Agenda - Executive Policy Committee – October 31, 2012

Item No. 1 Precinct Plan – Rosser, Old Kildonan bounded by Jefferson and CPR, Inkster Gardens Neighbourhood bounded by Jefferson Avenue, King Edward Street and CNR line – Waterford Green (Old Kildonan and Point Douglas Wards) File SP 2/2012

Title: Precinct C (Waterford Green) Plan, SP 02/2012

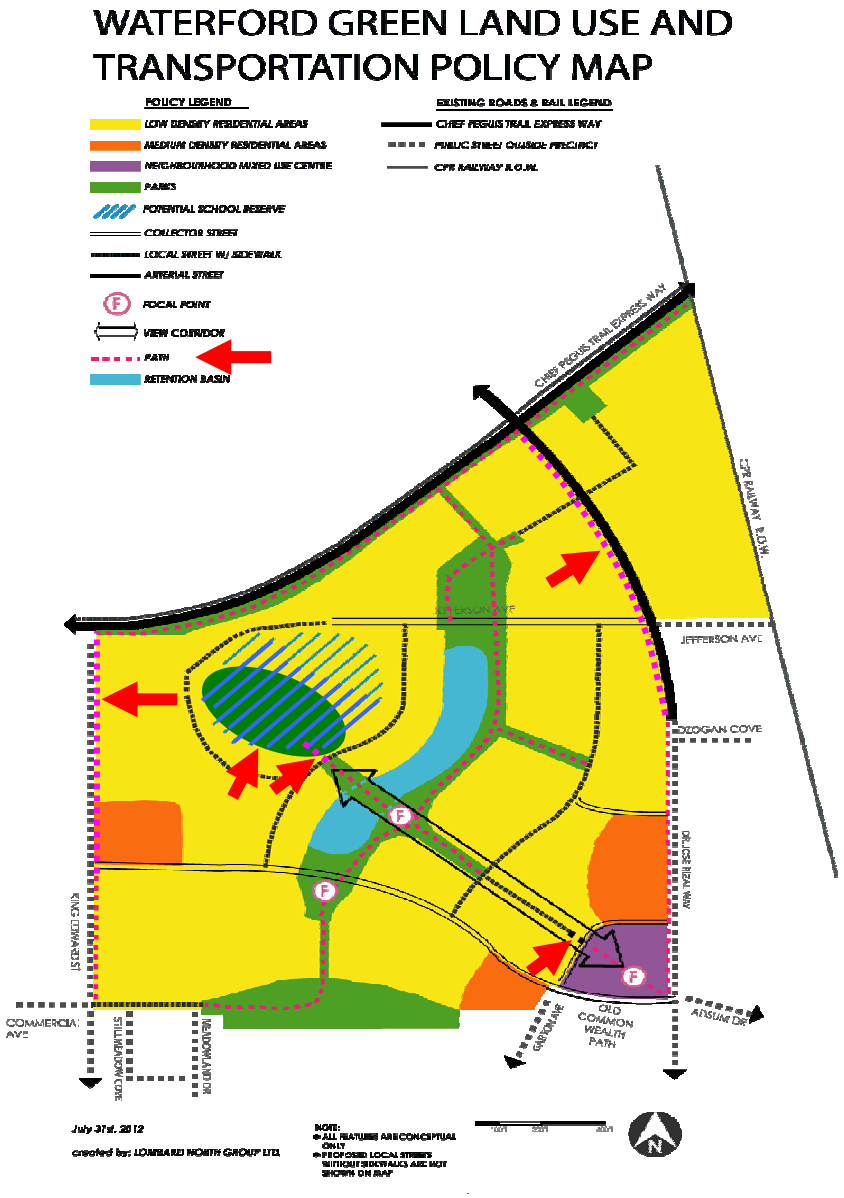
F. Replace the Waterford Green Land Use and Transportation Policy Map with the map in Attachment E – Amended Waterford Green Land Use and Transportation Policy Map, not including the red arrows which only identify the amendments to the map.

Note: Red arrows only identify amendments and should not be included in the approved Plan.
